# NOPOWER, $V_{On\_PD}$ , and $V_{Off\_PD}$ v110

This comment addresses r01-450, 449, 347, 451, 348, 349, 452, 227, 314, 353, and 238.

Figure 145–26—Single-signature PD state diagram (continued)

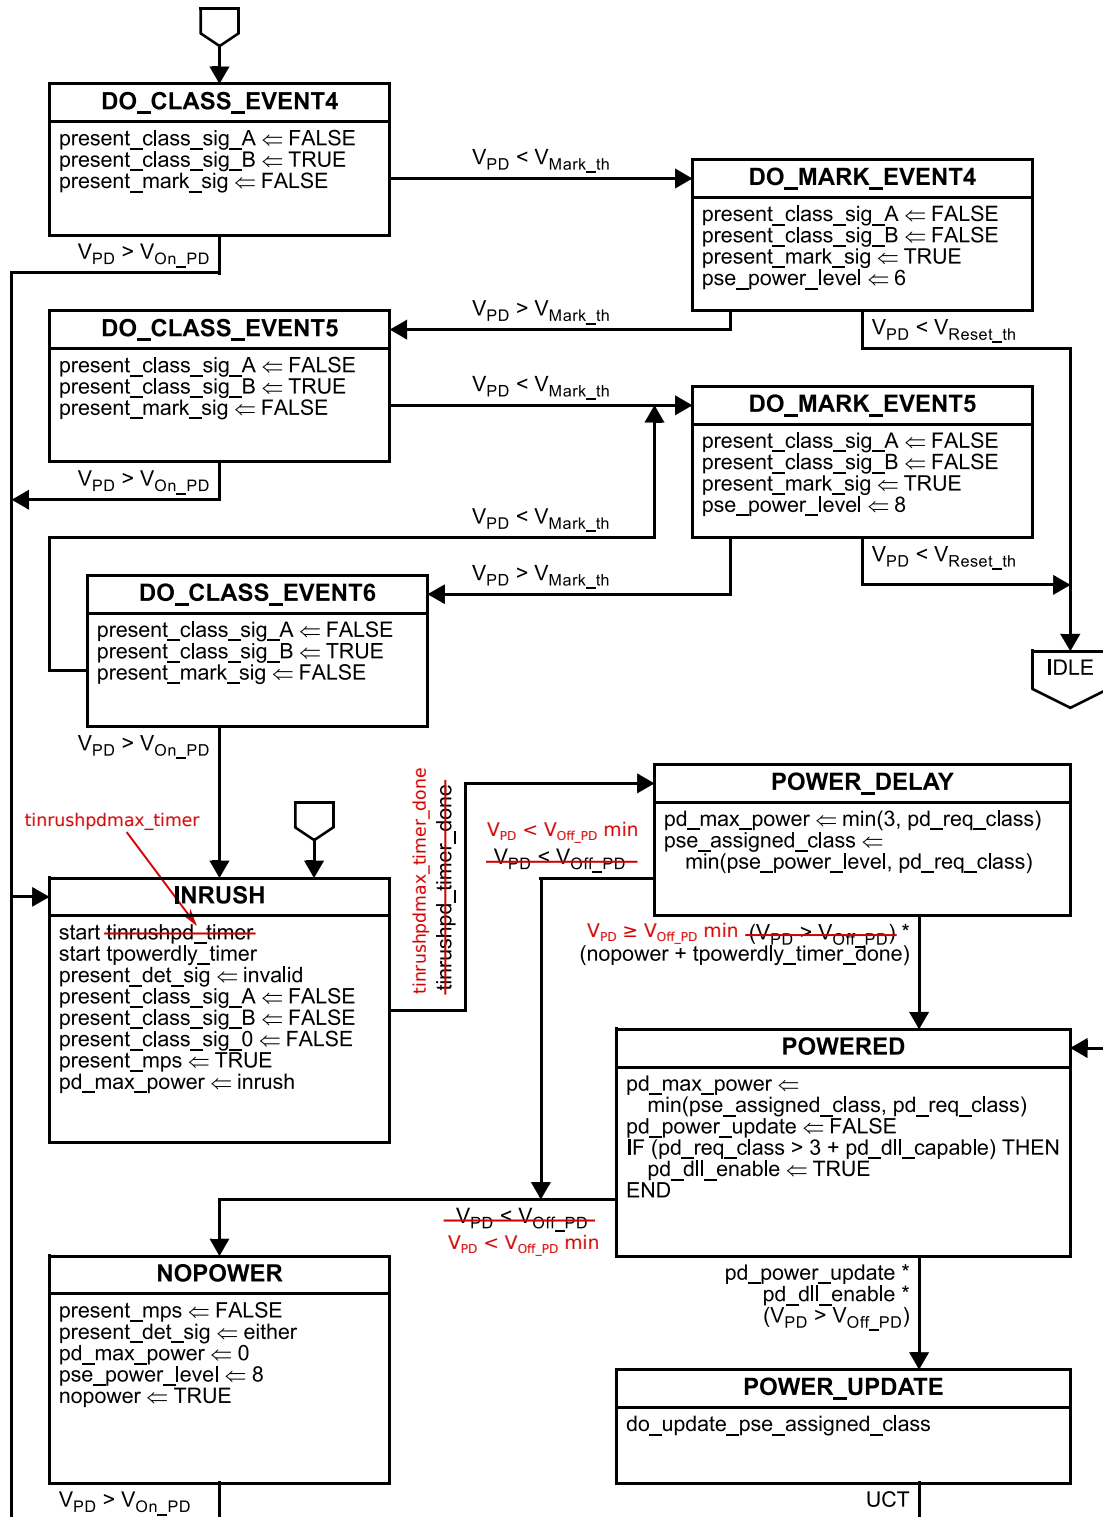
The state diagram implements this turning off of the PD with the NOPOWER state. Because the state diagram reacts instantaneously, depending on the value of  $V_{Off\_PD}$ , it can happen that peak power draw, or a transient event causes the PD to transition to NOPOWER. Because NOPOWER is also used to specify behavior for PDs that are intentionally drawn back into mark/class/ $V_{Off\_PD}$  range, a conflict arises, because a pass through the NOPOWER state allows the PD to change it class event counter.

Another way to make an unwarranted pass through NOPOWER is for the PD the intentionally transition from INRUSH to POWER\_DELAY before  $V_{PD}$  is in the  $V_{Port\_PD-2P}$  range. This must also be prevented.

Change Figure 145–26 as follows:

- the PD state diagram is forced to spend precisely 50 msin INRUSH (the state, not the condition).
- the entry logic into NOPOWER is changed to be  $V_{PD} < V_{Off\_PD}$  min.
- Add requirement that states a PD can't turn off due to compliant peak power draw or transients.

Figure 145–28—Dual-signature PD state diagram (continued)

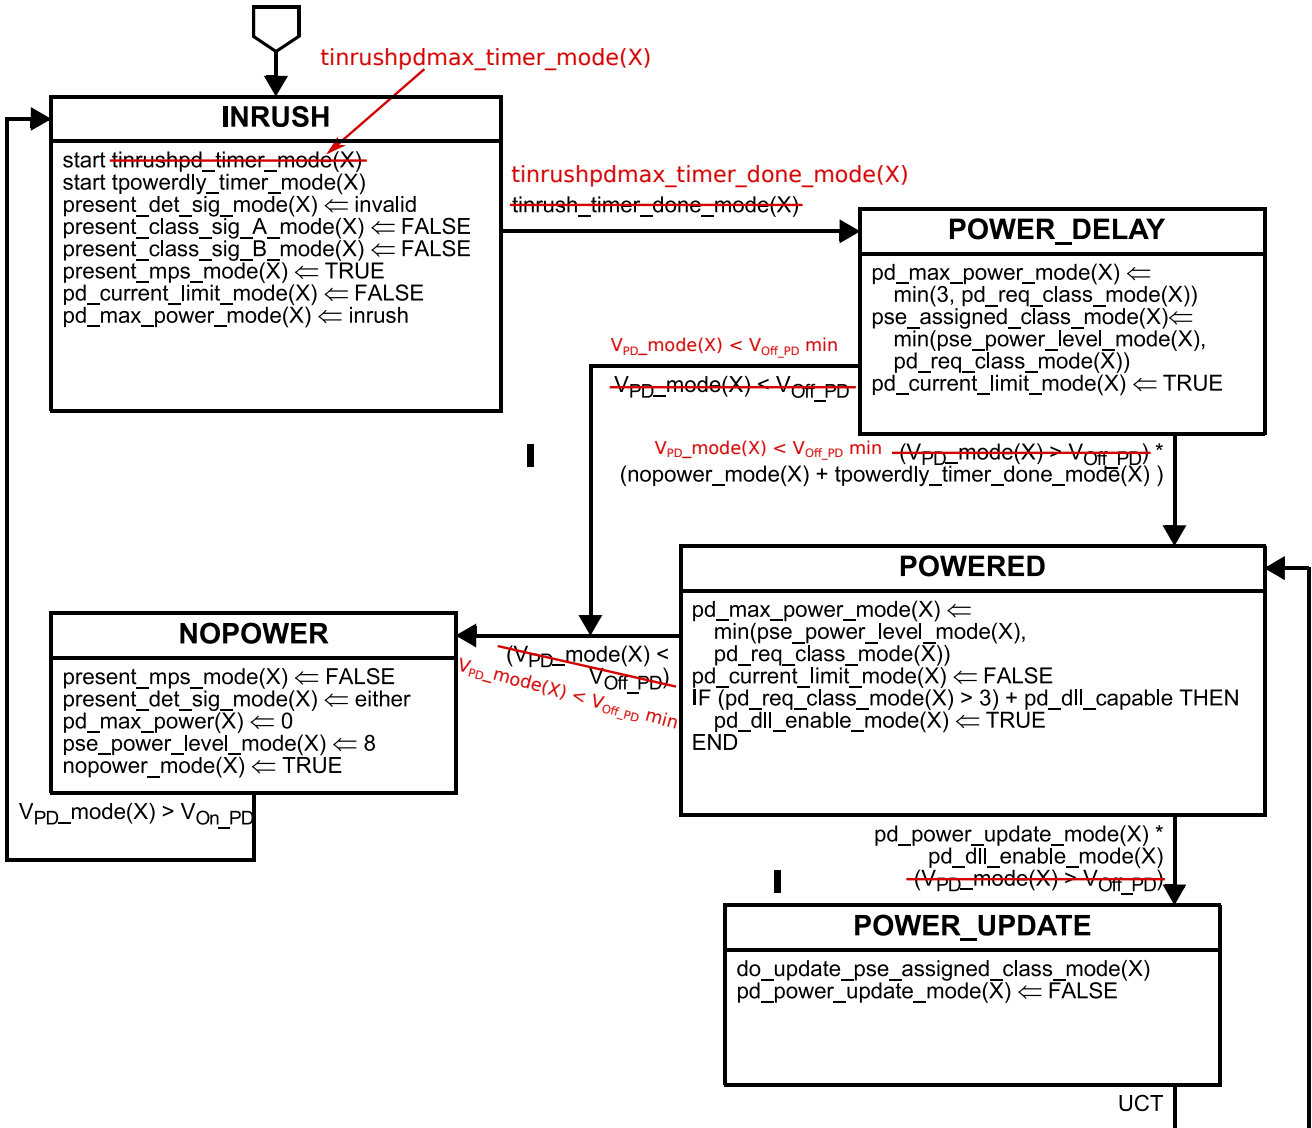
Change Figure 145–26 as follows:
